## THE NORTH EDGE 1405 NORTH FEDERAL HIGHWAY APPLICABLE CODES DELRAY BEACH PALM BEACH COUNTY, FL OCCUPANCY CLASSIFICATION

REVISED 12/01/22  
AS PER DEVELOPMENT SERVICES  
COMMENTS:  
1. UPDATED RENDERING AND  
ADDED RENDERING NOTE.

THIS DRAWING IS NOT FOR CONSTRUCTION,  
IT HAS BEEN ISSUED FOR GOVERNMENTAL  
REVIEW AND/OR PRELIMINARY PRICING.

DRAWING TITLE  
**ENLARGED  
UNIT PLANS**

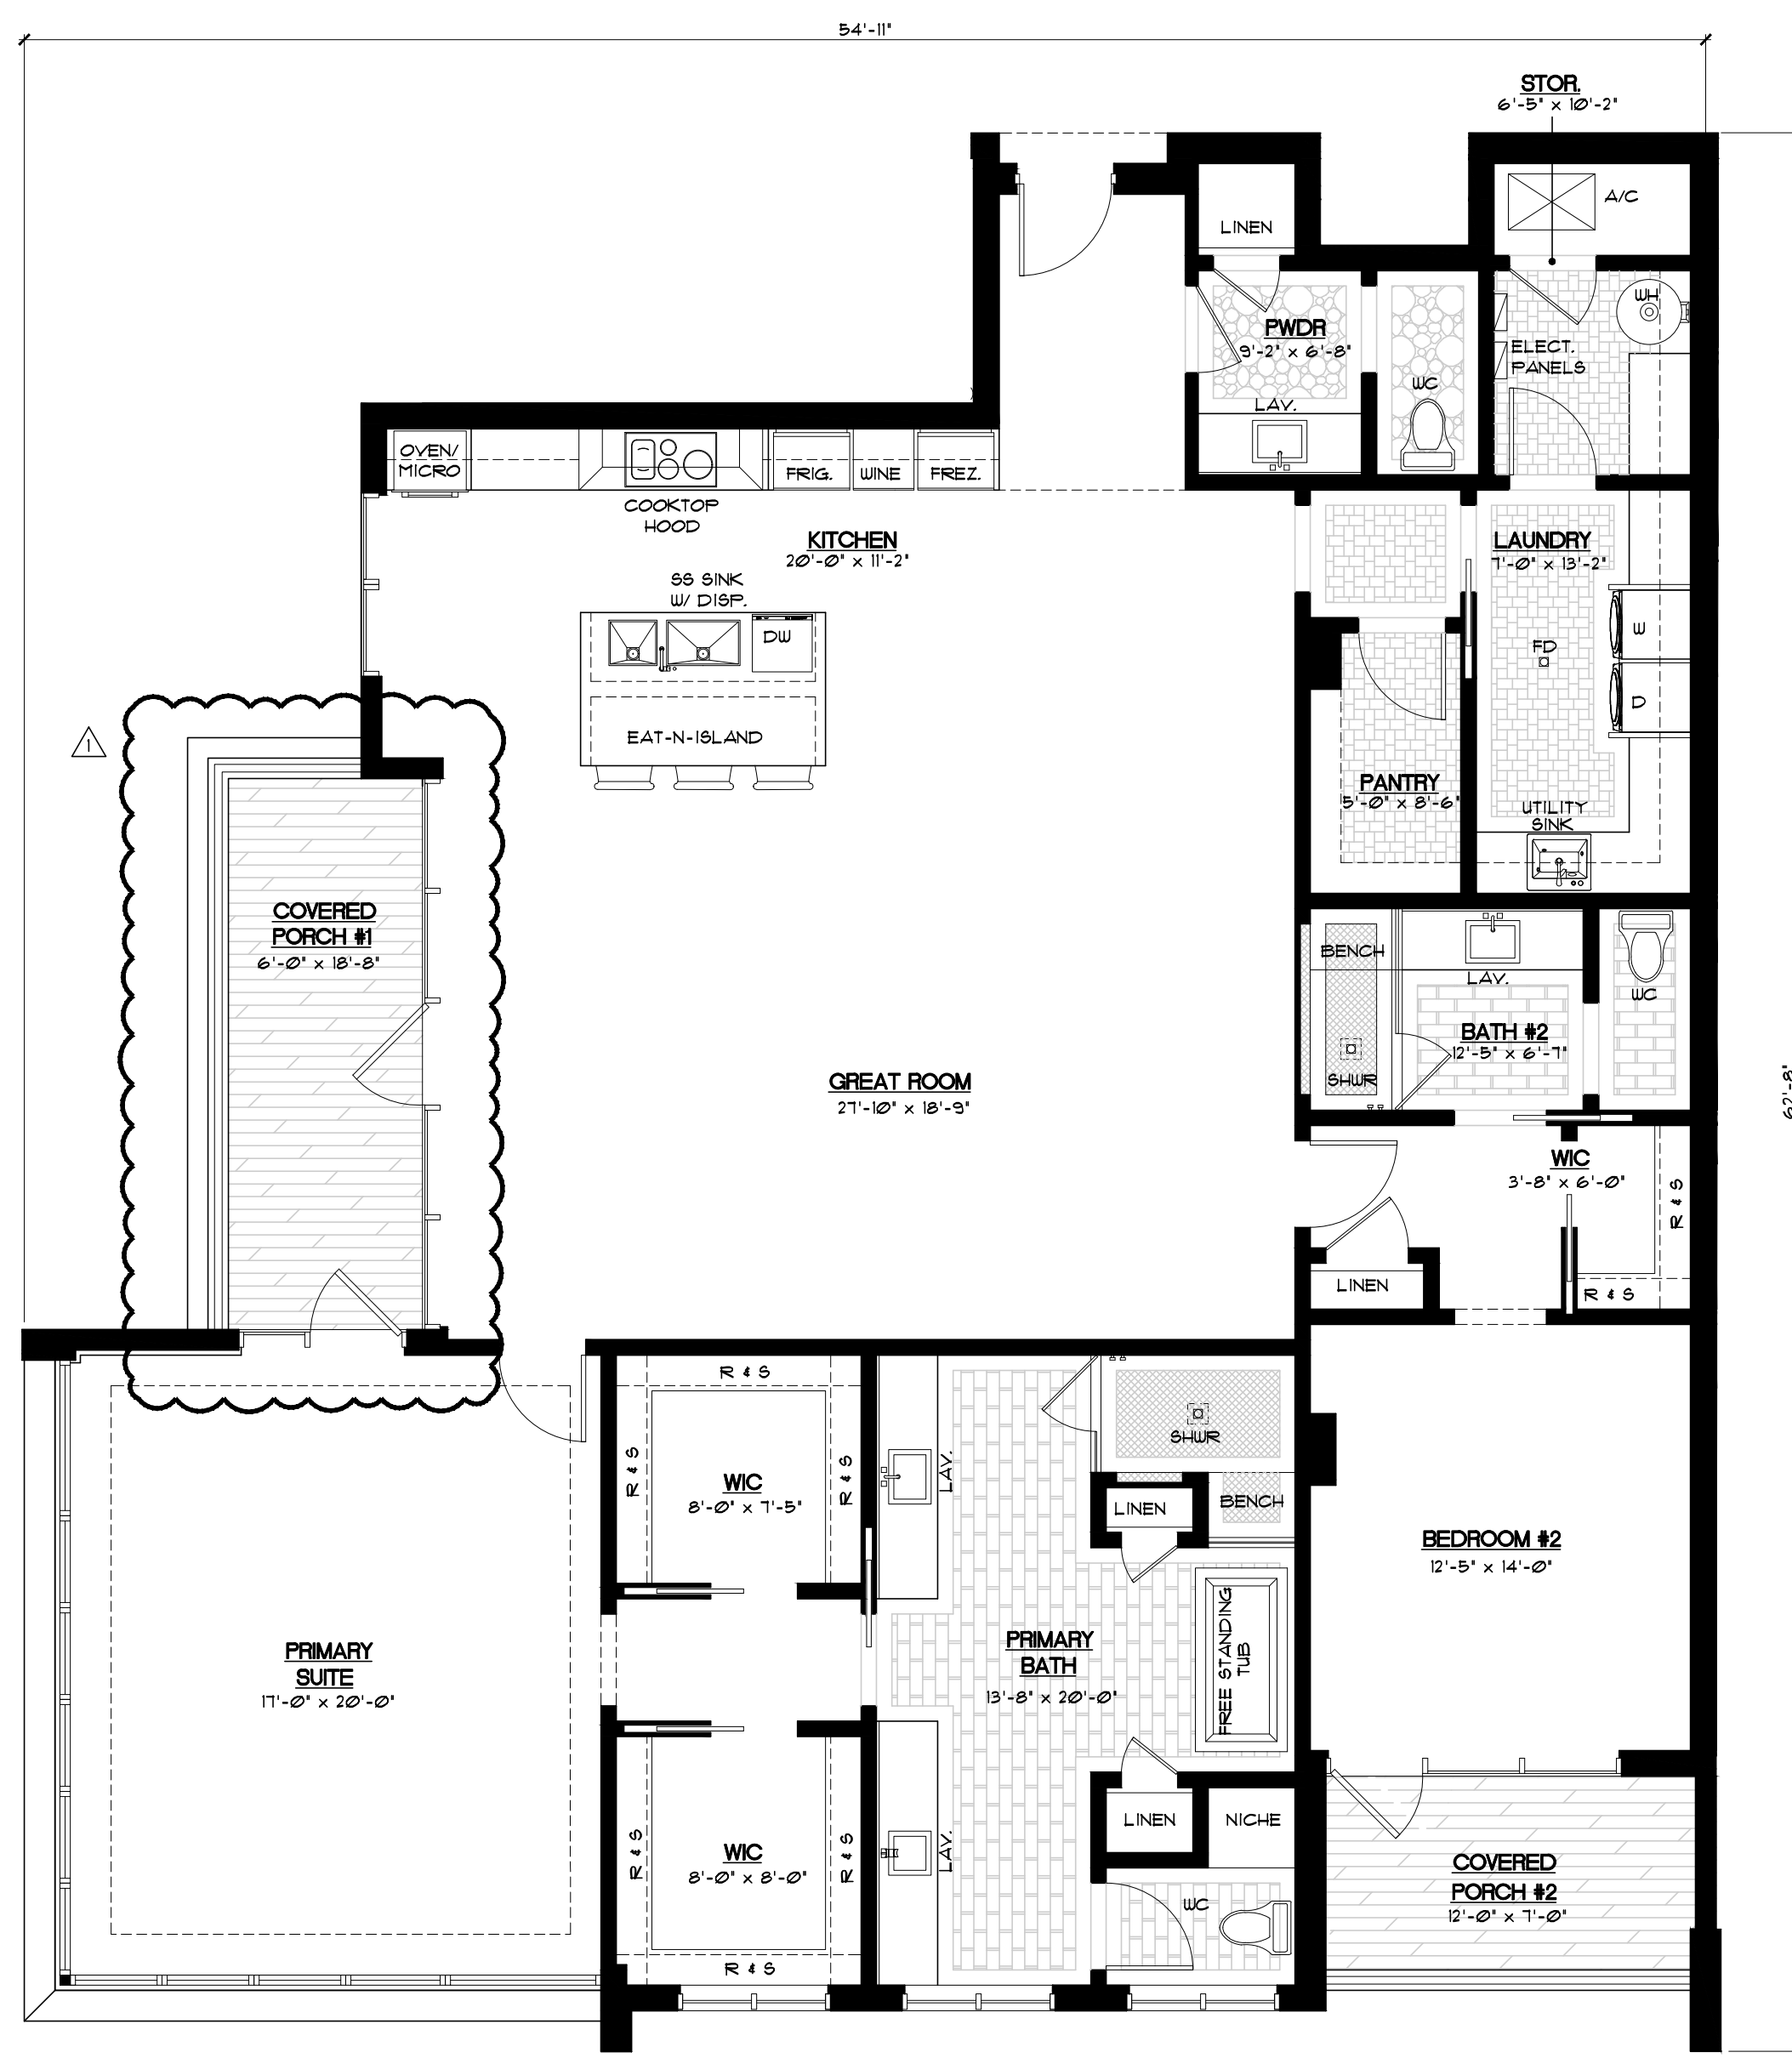
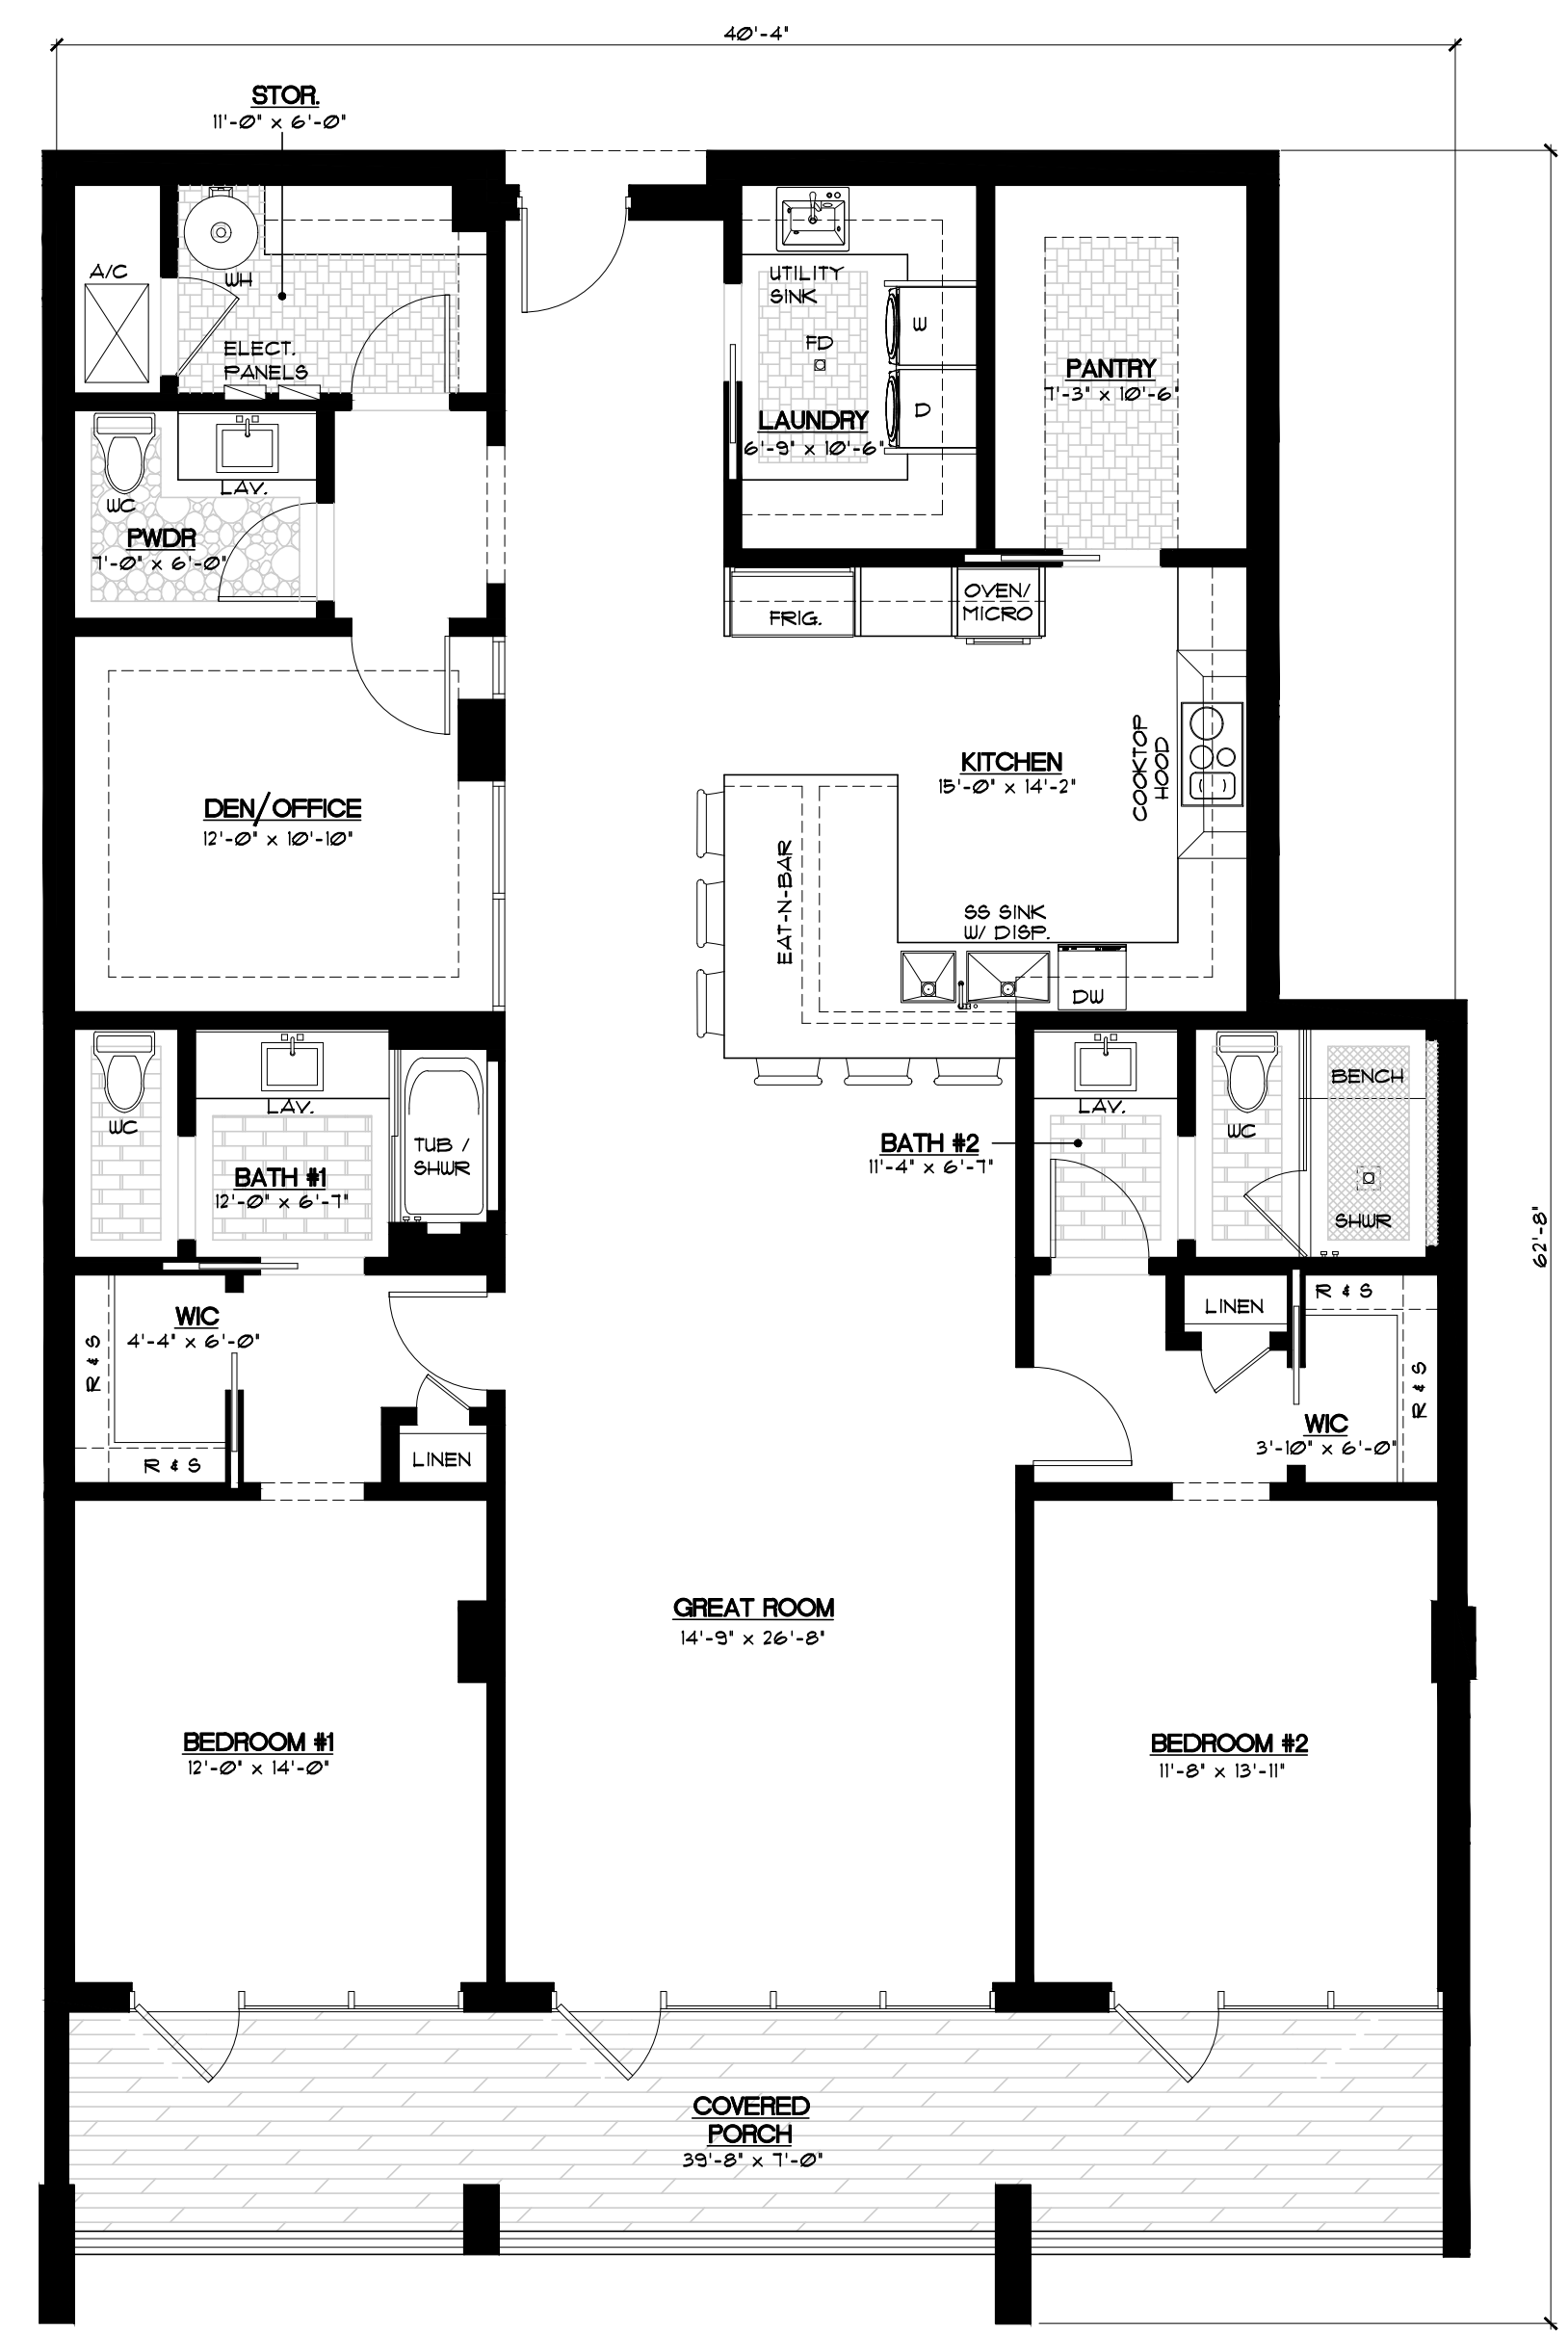
REVISIONS  
▲ REVISED 12/3/22  
AS PER DEVELOPMENT SERVICES COMMENTS:  
1. UNIT 202; MADE PORCH #1 SMALLER  
2. UNIT 204; MADE PORCH LARGER  
3. MOVED THE TRASH CHUTE LOCATION TO THE WEST
